## Detail difference

Changed the mainboard circuit:

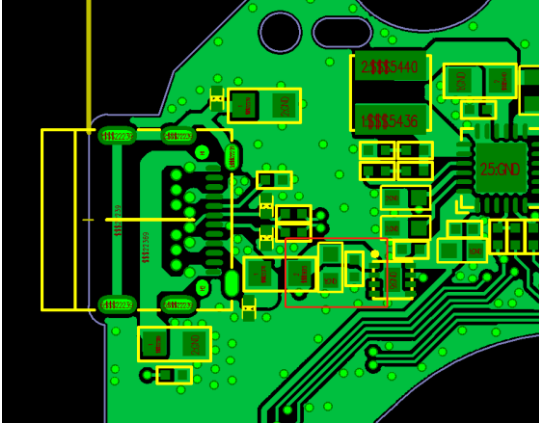
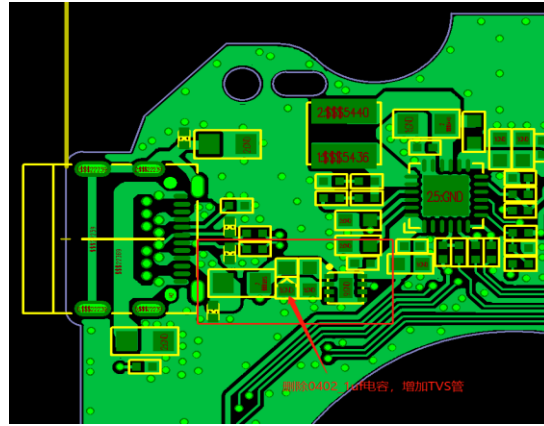
1. Remove the 0402 1 $\mu$ F capacitor and add a TVS diode.

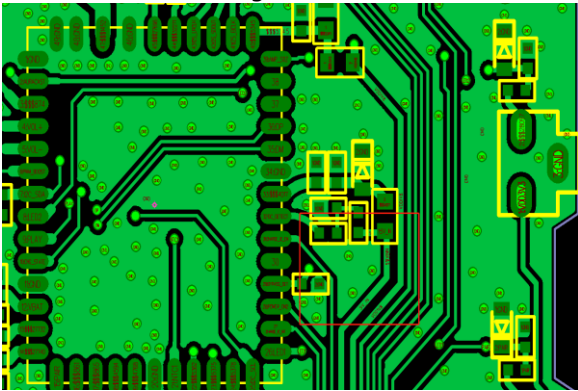
2. Add 0402 4.7k resistor
